Response to the Applicant's Noise Assessment Update

Note by William David Moore

Figure 1:

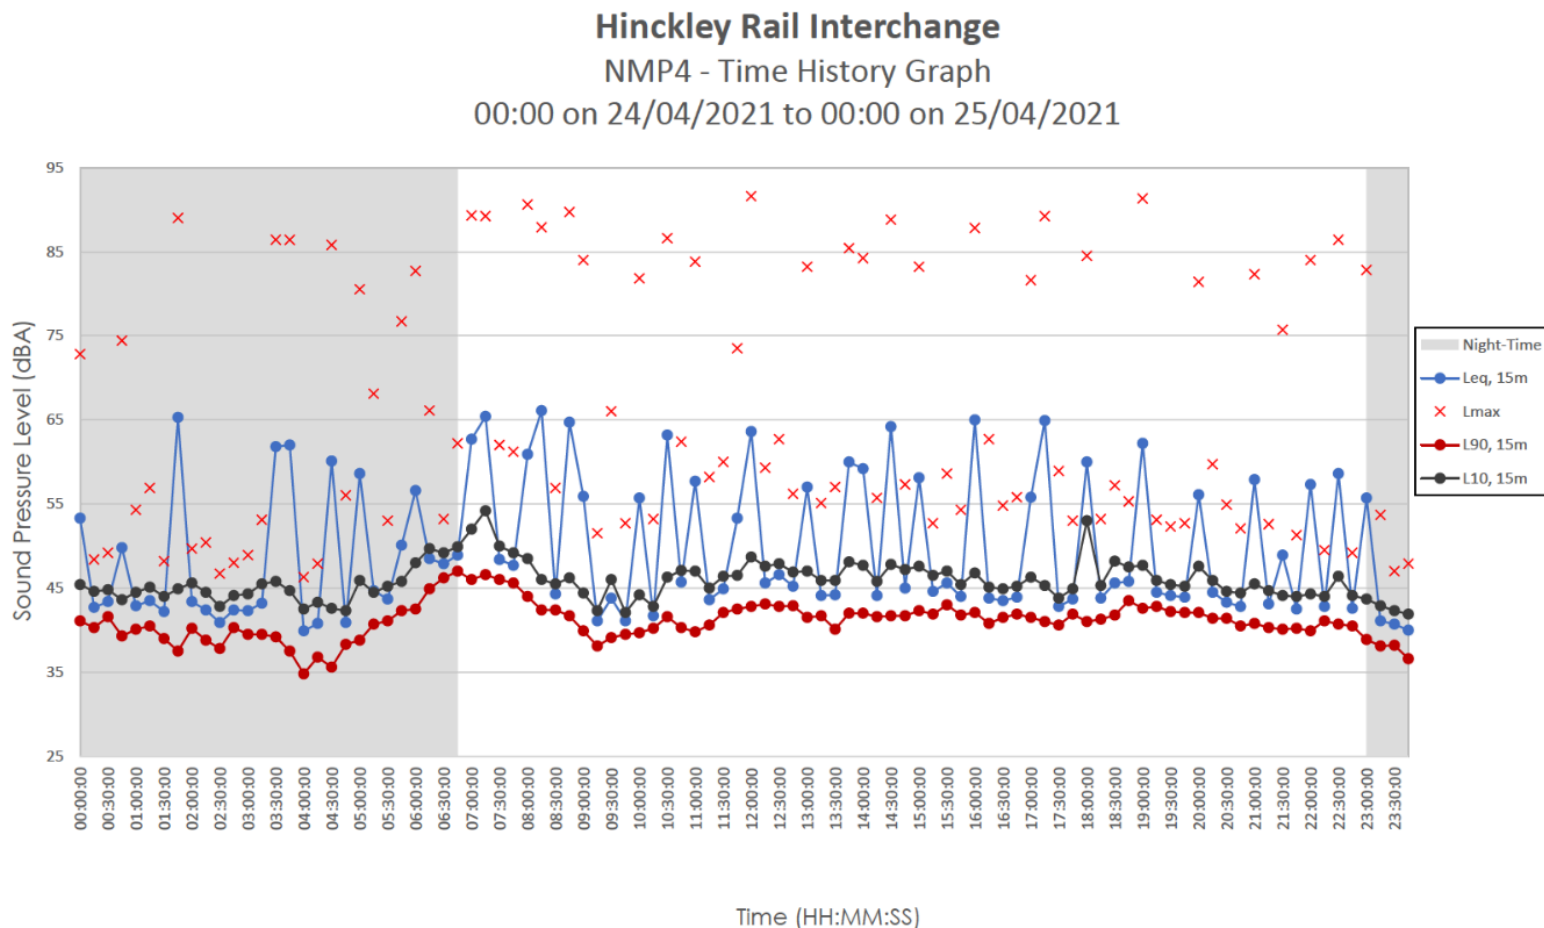
The ambient sound levels measured by NMP4 are utterly dominated by sound of extremely close proximity train pass bys with far lower sound levels when trains aren't passing by, i.e. almost all the time. Overwhelming evidence of this is contained within the summary results pages for NMP4, as explained below in points 1-4. An example summary results page is included in Figure 1, below.

1. The LAeq sound levels repeatedly spike up and down throughout the daytime and night-time by ~15-20 dB from the low-mid forties, up to 55-65 dB. These spikes are caused by the sound of extremely close proximity train pass bys. Distant road noise would not cause these repeated spikes.

2. If these high LAeq sound levels were caused by the distant road noise we would always see the LA10 levels spiking along with the LAeq levels, but we don't because they're caused by train pass bys and train pass bys are inherently brief.

3. If these spikes were caused by changes in the distant road noise, we would see significant changes up and down in LA90 levels, but we don't because they're caused by train pass bys and train pass bys are inherently brief. This is why there's a gap of 20 dB between the weekday daytime background sound level in the report and the weekday daytime ambient sound level in the report. The train pass bys have no impact on the measured background sound levels, which contain the distant road noise. This is why NMP4's measured background sound levels can simply be copied to NSRs 1-8 & 24-26.

4. The spread between the LA90 levels, LAeq levels, and LA10 levels is very tight in those 15 minute periods which don't contain spikes in LAeq levels. This is because these time periods are dominated by the distant road noise in the low-mid forties dB. The gap between the LA90 levels and the LA10 levels remains stable during periods with spikes in LAeq levels because the distant road noise is stable.
